PTN-NC-92-077

SUBJECT: Off Site Dose Calculation Manual

Attached is the revised version of Appendix C of the Off Site Dose Calculation Manual. Appendix C describes the Radiological Environmental Monitoring Program. This revision is the result of the modifications made due to hurricane Andrew and is summarized below.

**APPENDIX C**  
**RADIOLOGICAL ENVIRONMENTAL SURVEILLANCE**  
**TURKEY POINT PLANT**  
**Key to Sample Locations**

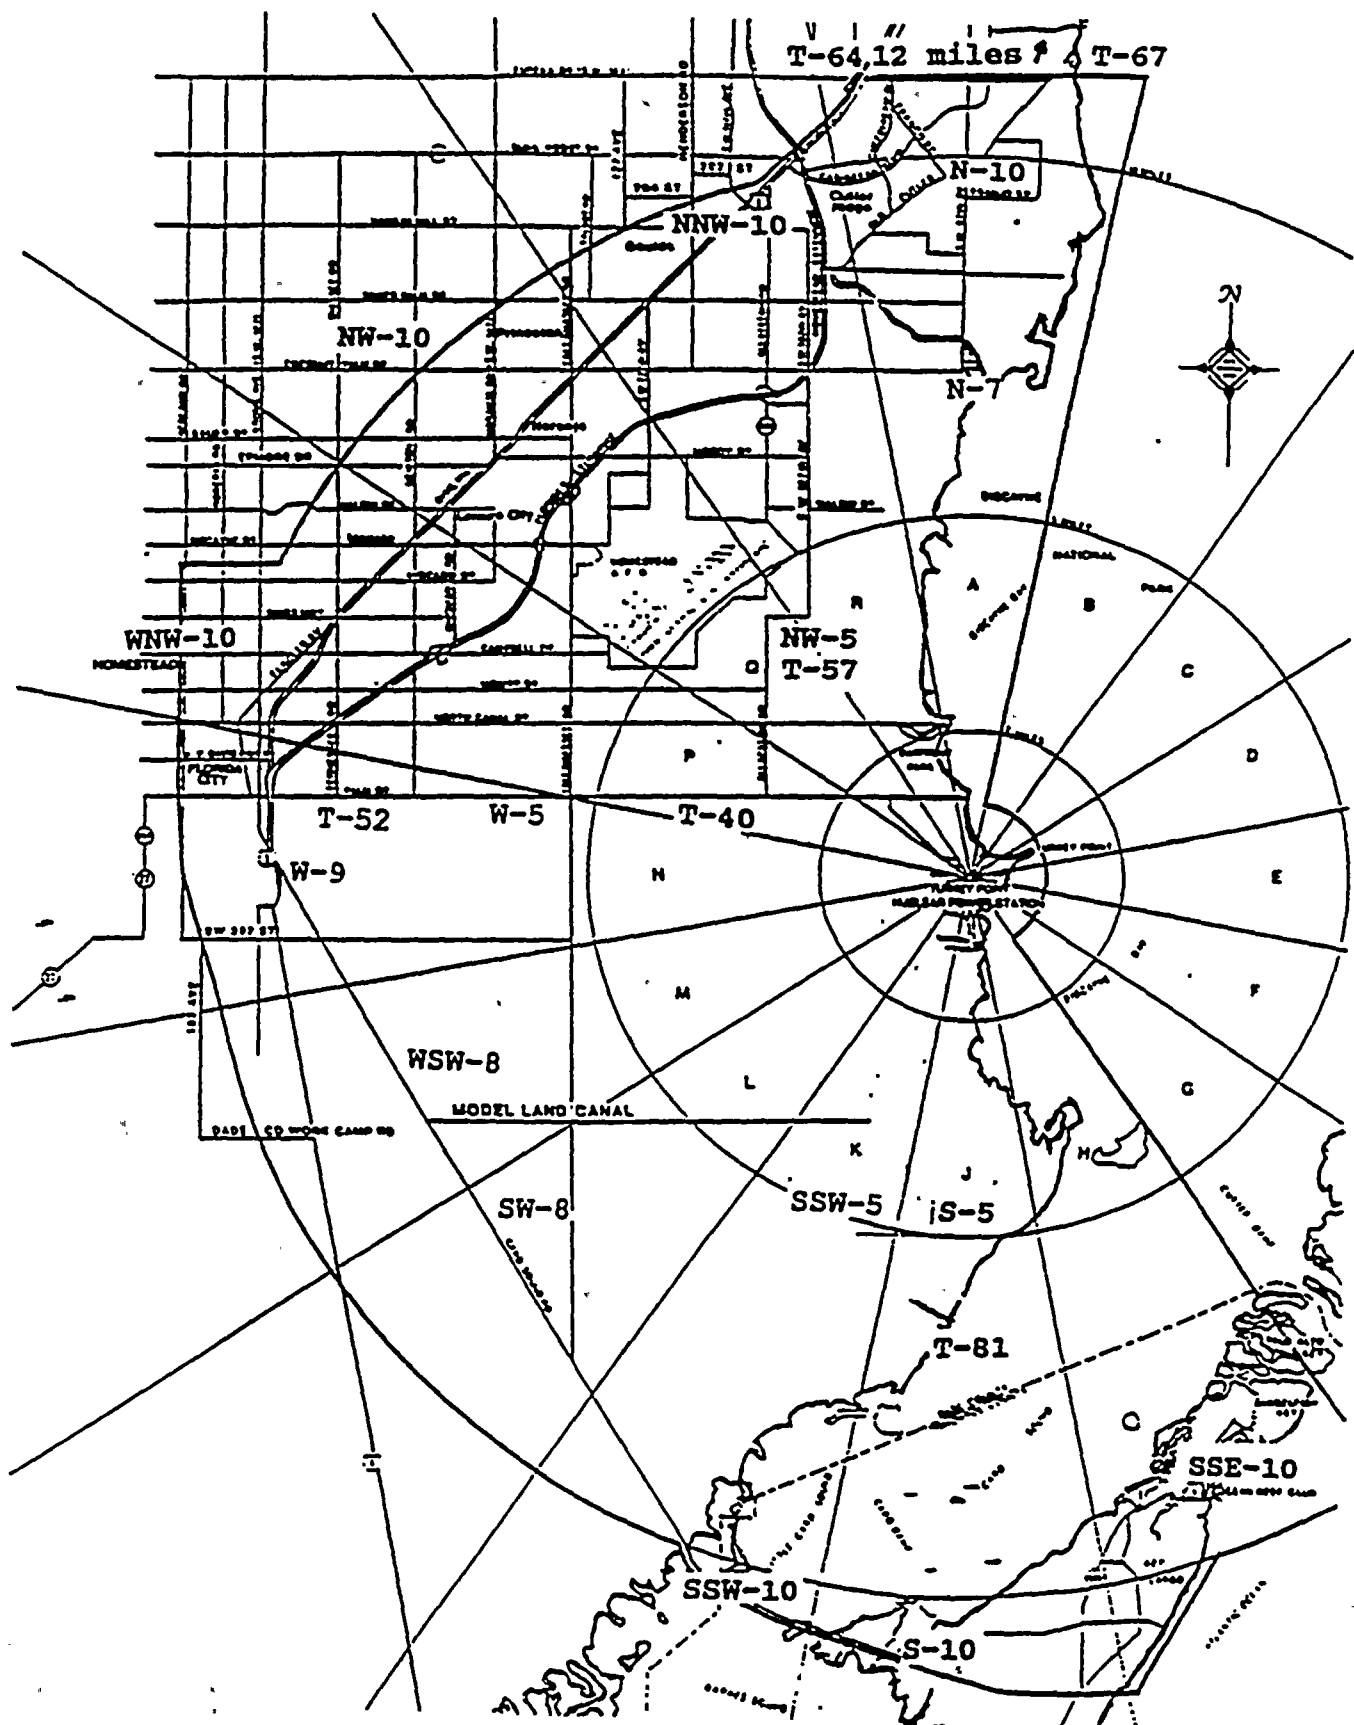
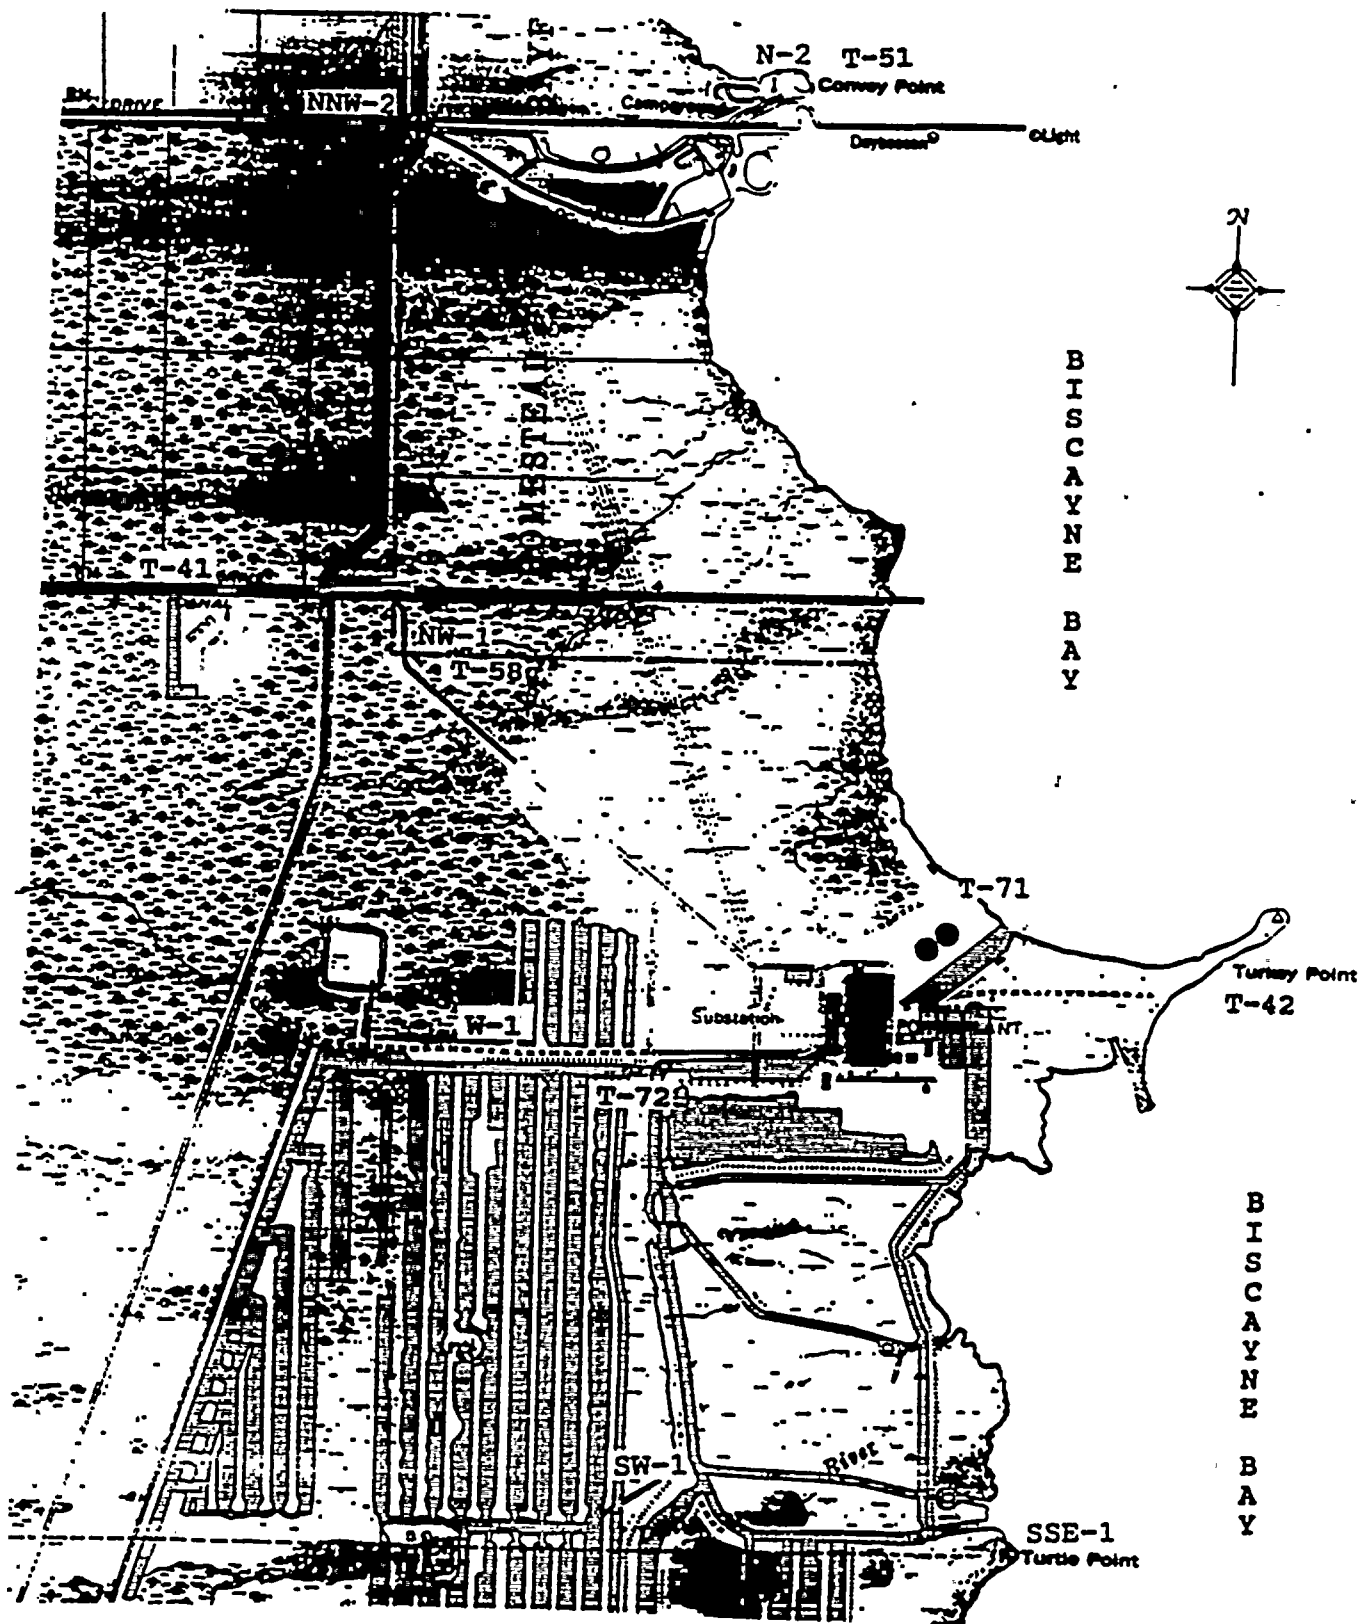
3. Revised Maps

Changed maps describing monitoring locations.
